# Access Compliance Report

## Public Rights-of-Way

Intersection ID: 3514	Main Street: OVERLOOK_MOUNTAIN_DR	Cross Street: TRANQUILLITY_DR	Location: S
ADA ID: 08E3016708A1	Ramp Type: Perp	Initial Pass/Fail: Fail	Overall Compliance: No
Severity Score: 12.5			
Codes/Mitigation Info/Possible Solution		Field Measurements/Component Compliance

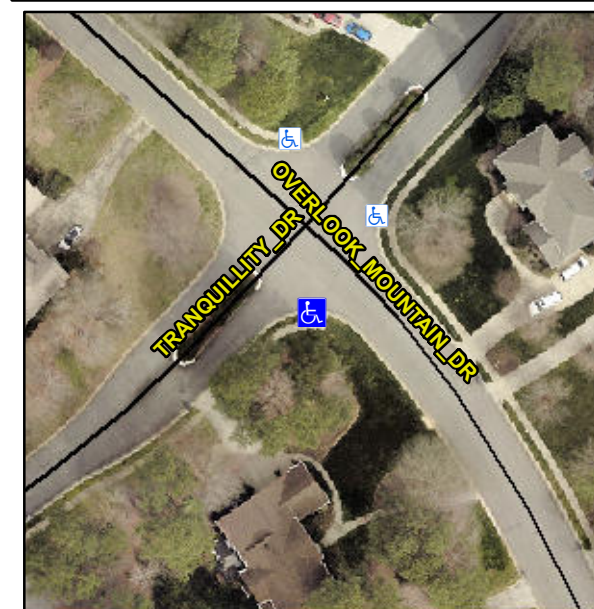
**Not Found, R304.2.2**

Compliance	Description	Data	Compliance	Description	Data
N/A	Ramp Length (in)	49.0	No	Ramp Slope (%)	10.1
Yes	Ramp Width (in)	48.0	Yes	Ramp XSlope (%)	0.4
N/A	Flare Type LT	N/A	N/A	Flare Type RT	N/A
N/A	Flare Slope LT (%)	N/A	N/A	Flare Slope RT (%)	N/A
N/A	Flare Traversable LT?	N/A	N/A	Flare Traversable RT?	N/A
N/A	Landing Length (in)	N/A	N/A	DWS Provided?	N/A
N/A	Landing Width (in)	N/A	N/A	DWS Contrast?	N/A
N/A	Landing Slope (%)	N/A	N/A	DWS Length (in)	N/A
N/A	Landing X Slope (%)	N/A	N/A	DWS Full Width?	N/A
N/A	Landing Curb? (Y/N)	N/A	N/A	DWS Offset (in)	N/A
N/A	Shared Landing?	N/A			
N/A	Gutter Ponding?	N/A	N/A	Gutter Slope (%)	N/A
N/A	Gutter Lip Ht (in)	N/A	N/A	Gutter X Slope (%)	N/A
N/A	Painted X Walk1?	No	N/A	Painted X Walk2?	N/A
	X Walk 1 Direction	To NE		X Walk 2 Direction	N/A
N/A	X Walk 1 Width (in)	N/A	N/A	X Walk 2 Width (in)	N/A
	X Walk 1 Slope (%)	0.3		X Walk 2 Slope (%)	N/A
	X Walk 1 X Slope (%)	0.4		X Walk 2 X Slope (%)	N/A

**Remove & Replace Entire Ramp.**
